# SERVICE BULLETIN

## SB-101722-D

**ID NUMBER & REVISION:** SB-101722-D  
**SUBJECT:** Canopy Latch Installation  
**RELEASE DATE:** 19 August 2024  
**EFFECTIVE DATE:** 19 August 2024  
**SUPERSEDES NOTICE:** SB-101722-C

**AIRCRAFT AFFECTED:** **MAKE & MODEL:** ICON A5  
**SERIAL NUMBERS:** ASN: 00130 – 00153; 00155; 00156; 00158 – 00166  
**REQUIRED ACTION:** Inspect the canopy latch mechanism for proper torque and installation. Adjust the canopy latch mechanism if torque specifications are not met.

Figure 1 Bolts and Back of Strike Plate

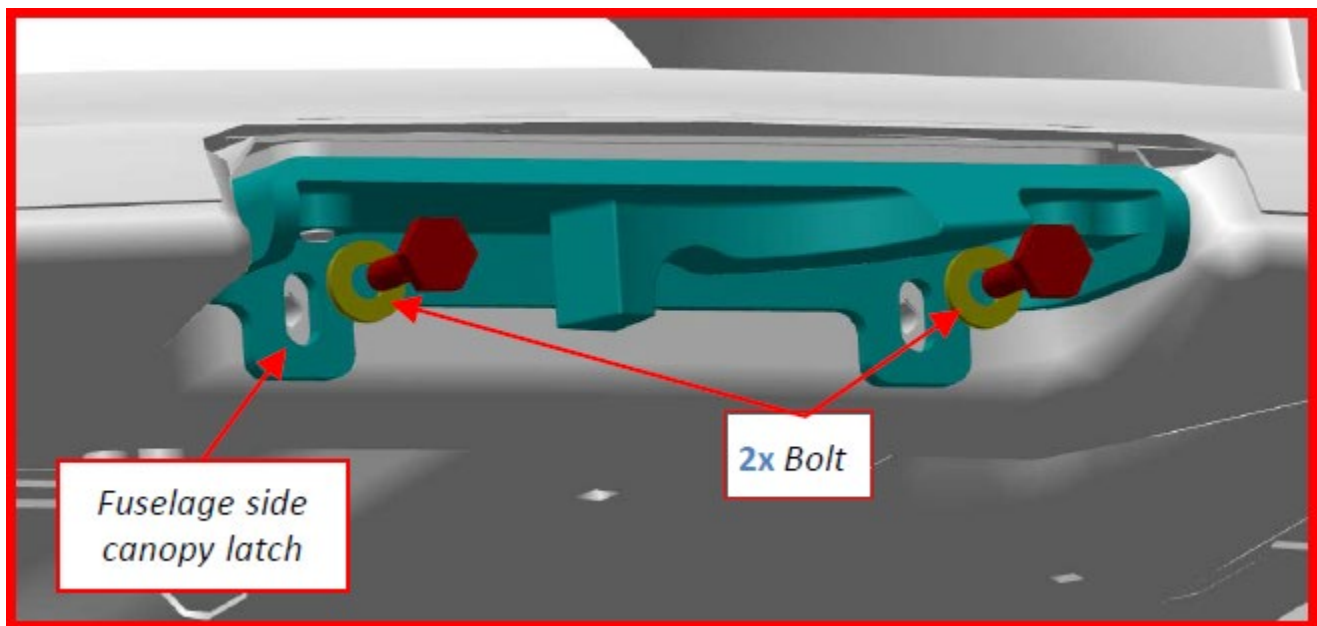
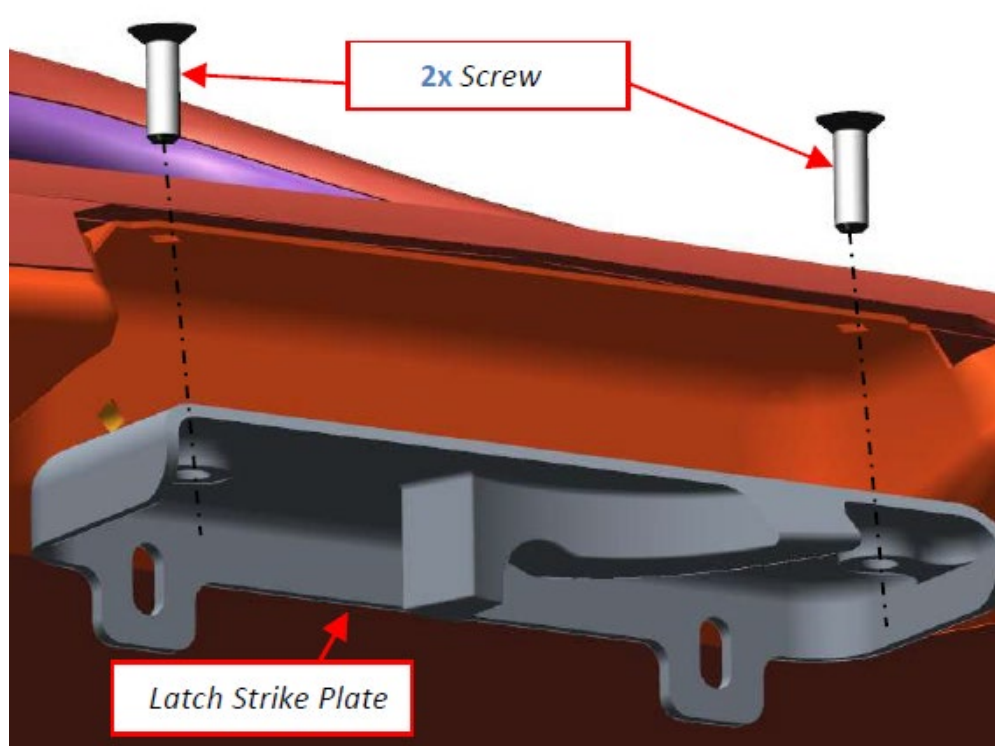
1. Lift the canopy up and out of the way
2. Loosen the two bolts on the back of the strike plate
  - a. See Figure 1

4. Torque the two bolts on back of the strike plate (Figure 1) to 25-28 in-lb.

**SERVICE BULLETIN****SB-101722-D***Figure 2 Screws on Top of Strike Plate*

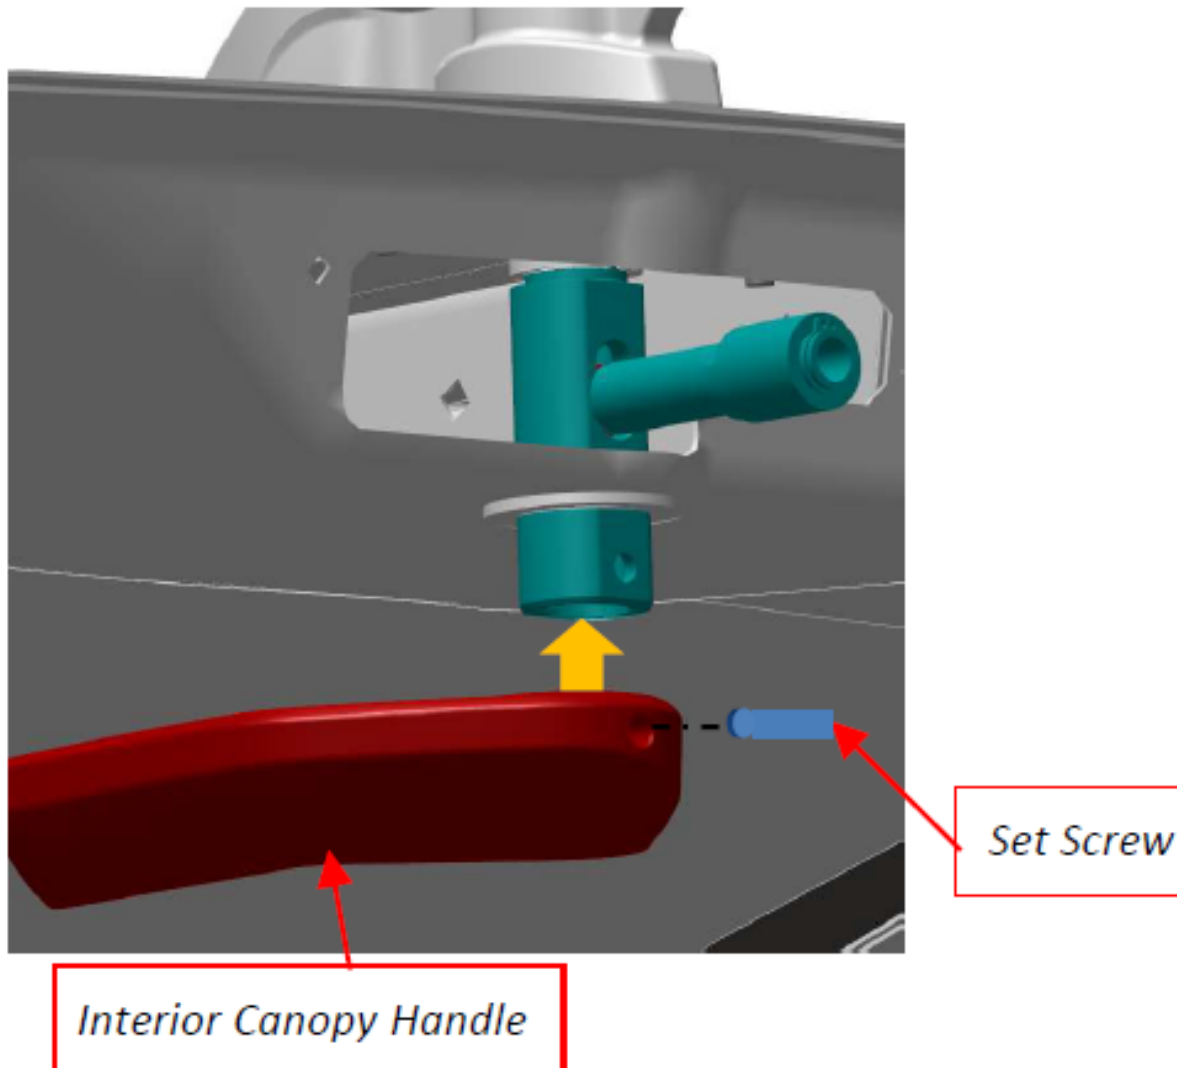
3. Inspect the two screws on top of the strike plate
  - a. Remove sealant over screw heads, if present.
  - b. Verify the two screws are torqued to 25-28 in-lb.
  - c. See Figure 2

5. Validate the Canopy Latch torque after the latch striker arm is torqued to ensure nothing has changed
6. Install the canopy latch handle by inserting the handle over the canopy latch shaft and installing the set screw.
  - a. Apply Loctite 243 to the set screw
  - b. Torque set screw to 2-4 in-lb.
  - c. See Figure 3
7. As needed, refer to the latest revision of SL-072224 for application of sealant over screw heads shown in Figure 2 for leak mitigation.

*Figure 3 Interior Latch Handle***Snap Ring Inspection/Repair**

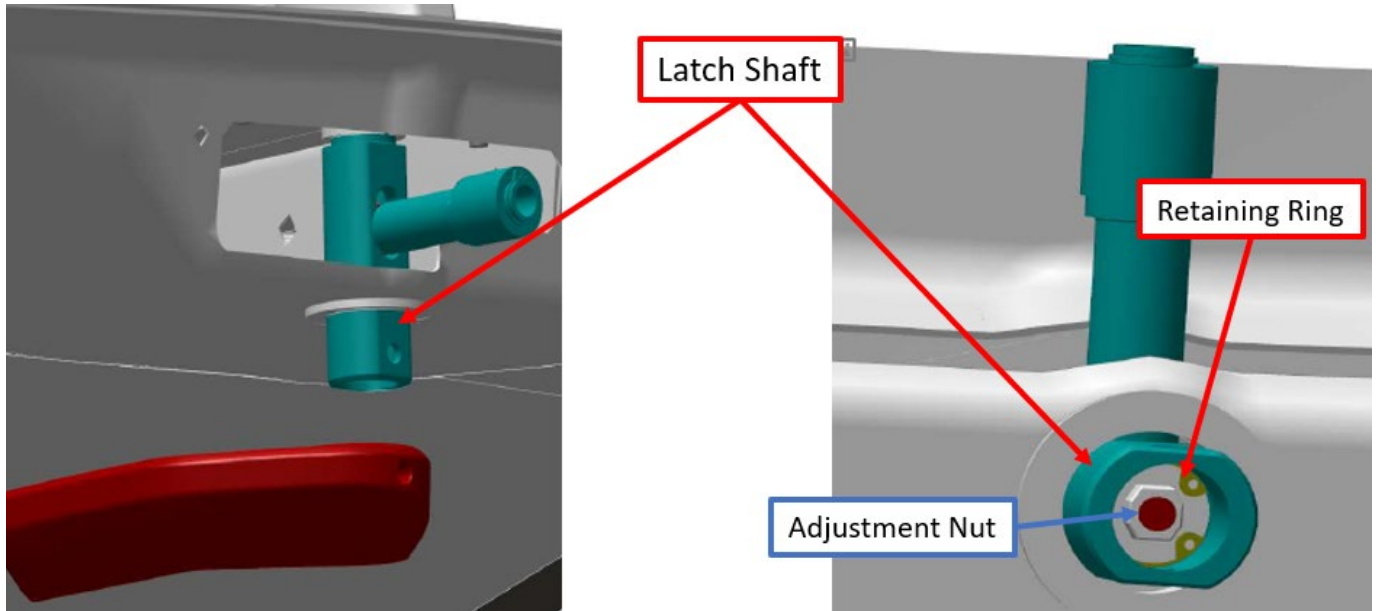
1. Sitting in the cockpit with canopy closed, remove the interior canopy latch handle by removing the set screw
  - a. See Figure 3

*Figure 4 Latch Shaft and Retaining Ring**Figure 5 Canopy Latch Shaft Retaining Ring*

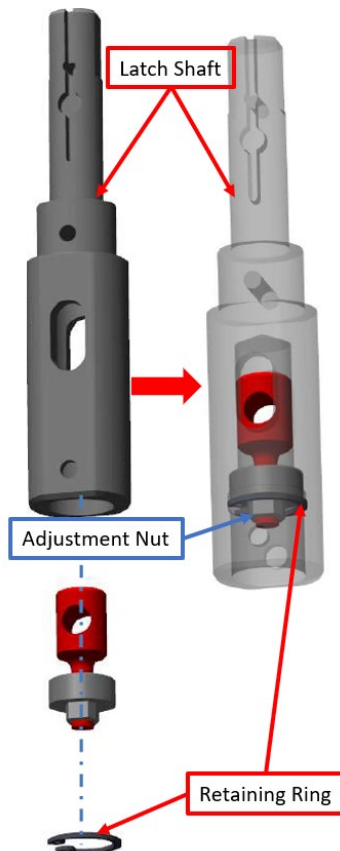
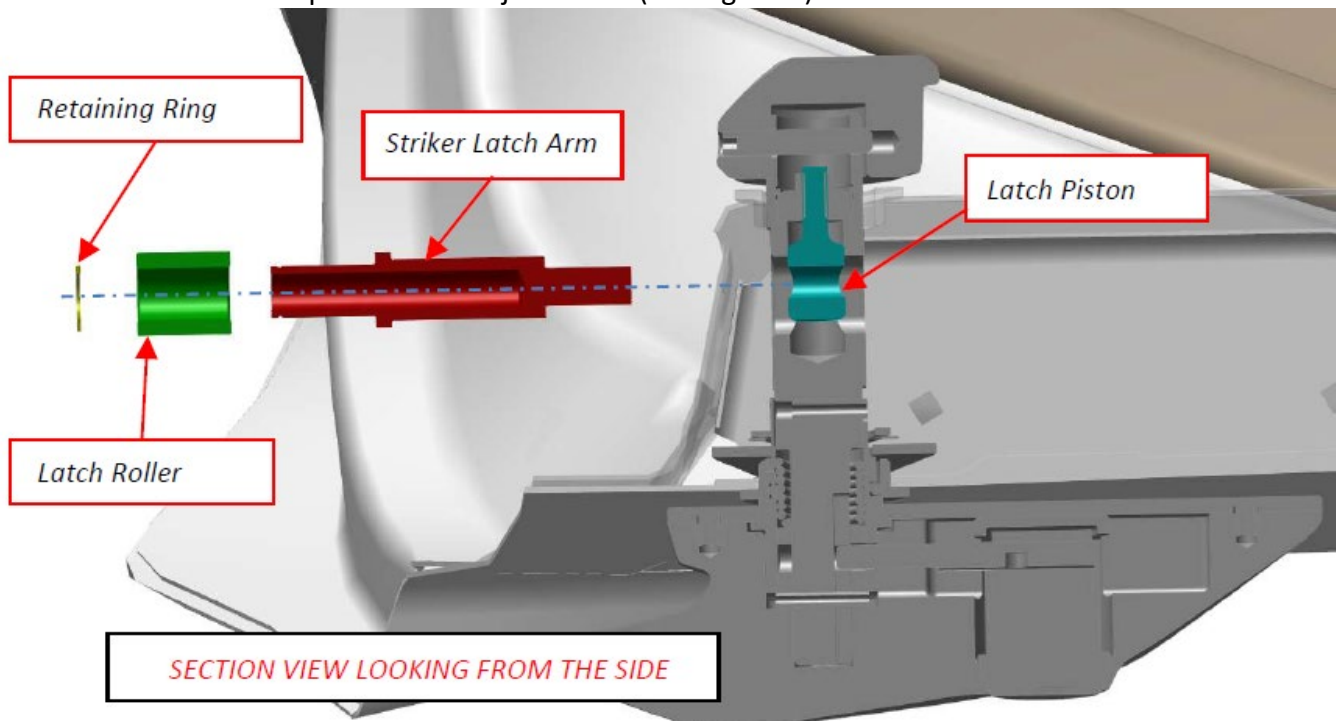
1. While seated in the cockpit, inspect the inside of the canopy latch shaft for proper installation of the retaining ring.
  - a. See Figure 4
2. Ensure the retaining ring is seated in the inner groove of the latch shaft
  - a. See Figure 5

*Figure 6 Striker Latch Arm*

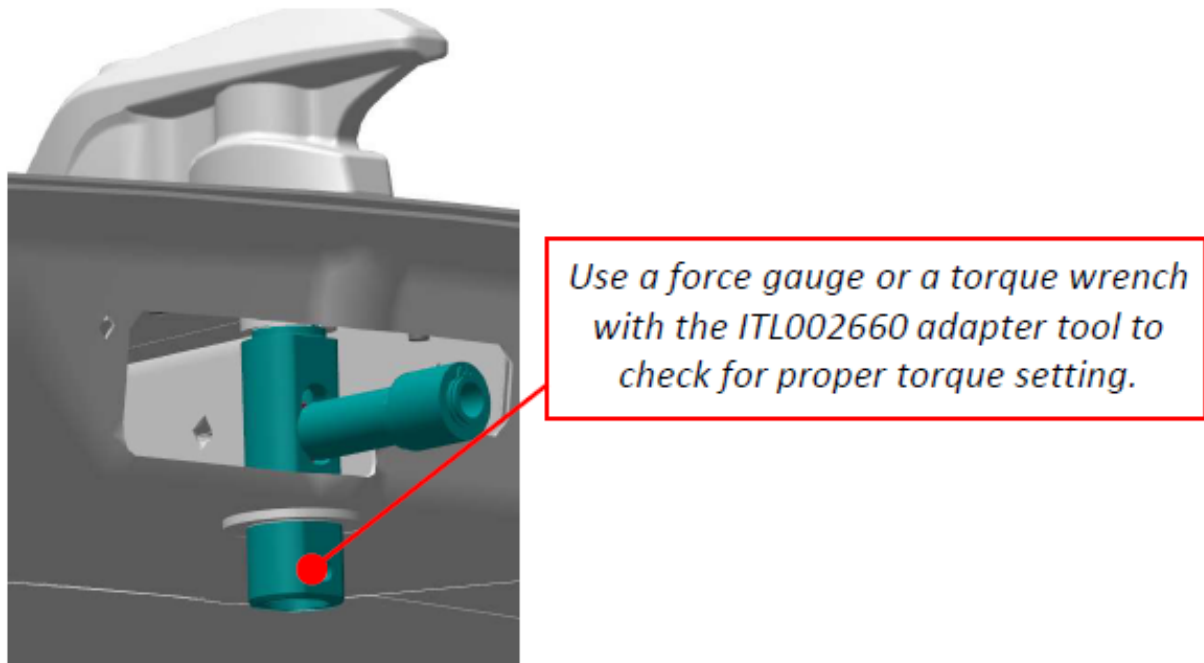
3. If the retaining ring is not properly seated into position:
  - a. With needle nose pliers, carefully push the retaining ring back into position by firmly pushing up on the retaining ring until it clicks/ snaps into place.
  - b. If Unable to confidently seat snap ring into place, loosen the striker latch arm to allow smooth up and down adjustments (see Figure 6)

**SERVICE BULLETIN****SB-101722-D***Figure 7 Torque Check on Canopy Latch**Figure 8 ITL Torque Tool for Torque Wrench*

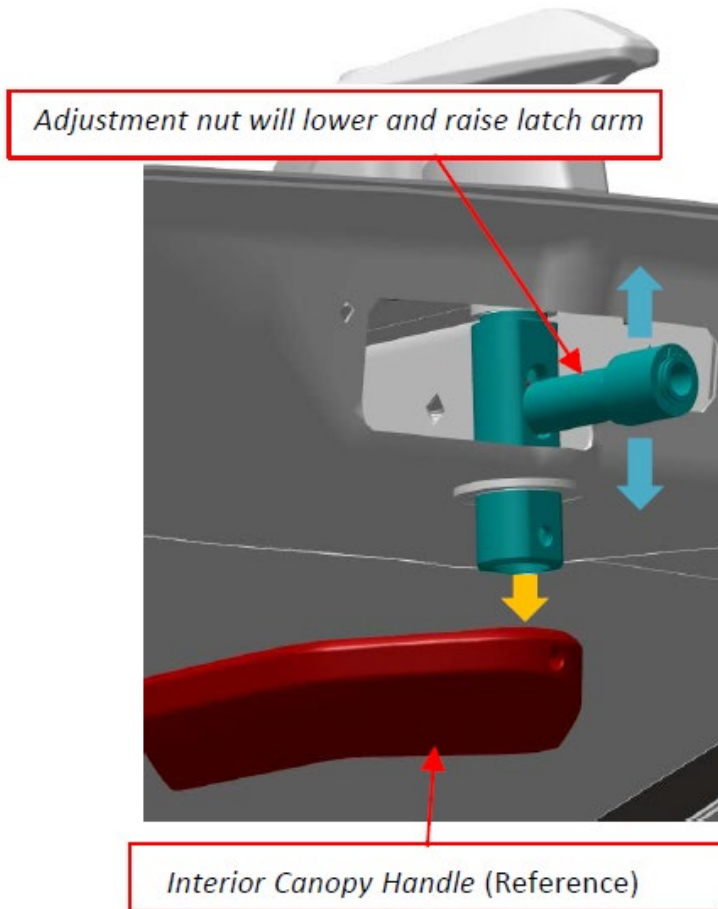
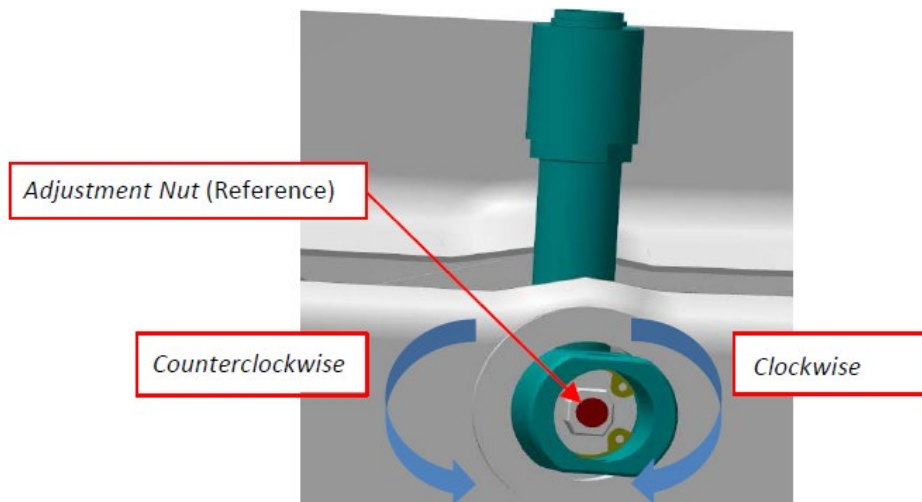
1. On the canopy latch shaft, use a force gauge or tool ITL002660 adapter and torque wrench (see Figure 8) to check the torque of the canopy latch mechanism.
  - a. 20 to 35 in lb to open canopy
  - b. 25 MAX in lb to close canopy
  - c. See Figure 7

Figure 11 Canopy Torque Adjustment

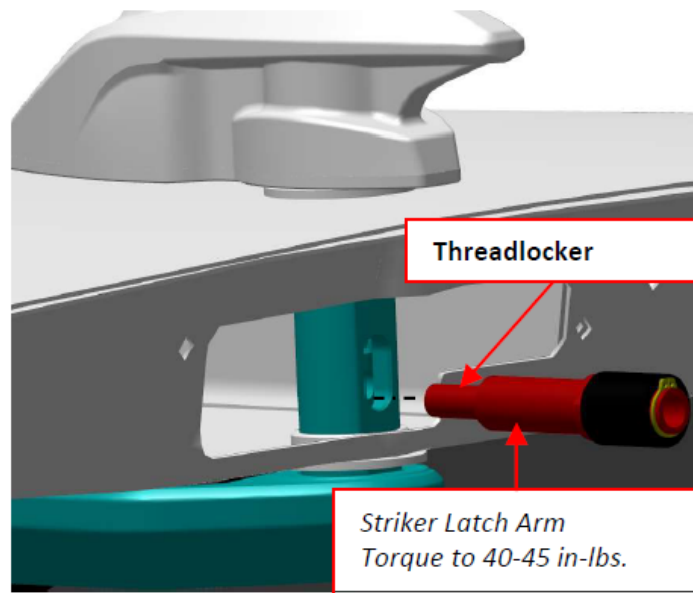
3. On the canopy latch shaft, use a force gauge or tool ITL002660 adapter and torque wrench (see Figure 8) to check the torque of the canopy latch mechanism.
  - a. 20 to 35 in-lb to open canopy
  - b. Verify that the close force is no more than 25 in-lb to close canopy
  - c. See Figure 11

Figure 12 Striker Latch Arm

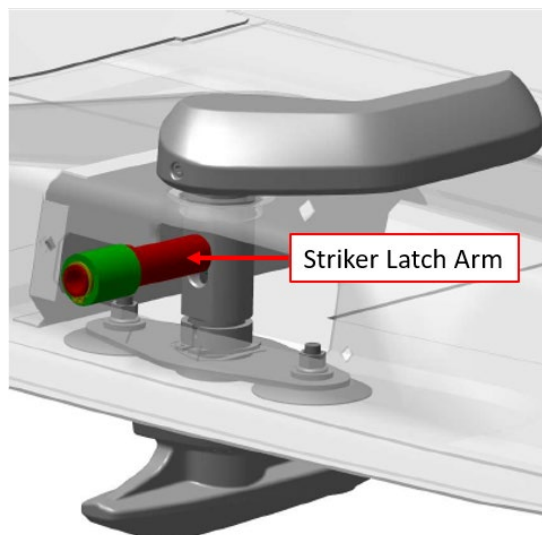
4. Torque Striker Latch Arm to 40-45 in-lb
  - a. See Figure 12
